TECHNICAL BULLETIN 429-15-42

MODEL AFFECTED: **429**

SUBJECT: **GTX 330 ES (ADS-B) TRANSPONDER (429-704-020) RETROFIT OF.**

HELICOPTERS AFFECTED: **Serial numbers 57001 through 57185 and 57289 equipped with GNS 530W and/or GNS 430W NAV/COM/GPS and Garmin GTX 330 Transponder.**

Figure 3

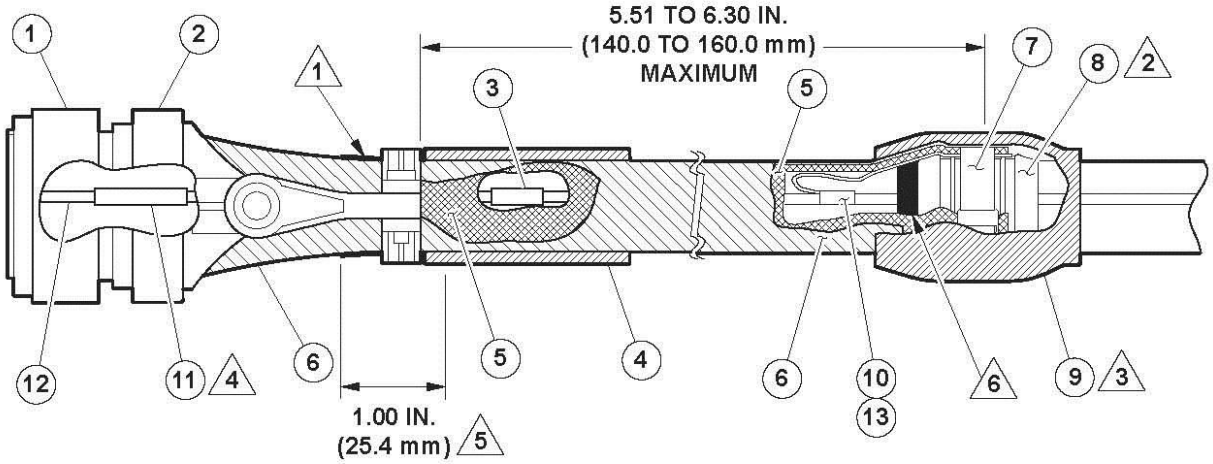
1. Use insulation tape (C-548) to build the wire bundle diameter (BHT-ELEC-SPM, Chapter 6).

2. Select the shield support ring (8) for the applicable connector/receptacle from the table below.

3. Insulation tape (C-548) may be used as an alternate for replacement of insulation sleeve.

4. When installing 24 gauge wire into 20 gauge contacts (12) and when specified in the instructions, a piece of insulation sleeve (11) shall be shrunk into position on the wire where it enters the connector grommet to effect a good environmental seal. The tubing shall not protrude more than 1 inch (25.4 mm) out of the connector grommet and shall fit snug tight on the wire insulation when shrunk. If a single piece of insulation sleeve does not provide sufficient diameter, then a second piece shall also be installed. Ensure that the insulation sleeve is not applied on any portion of the contact.

5. Wrap 1.5 to 2 turns of adhesive tape (C-460) between the wire bundle and braid sock (5) for protection against chafing.

6. Use adhesive tape (C-460) around the wire bundle to ensure a snug fit for the shield support ring (8).
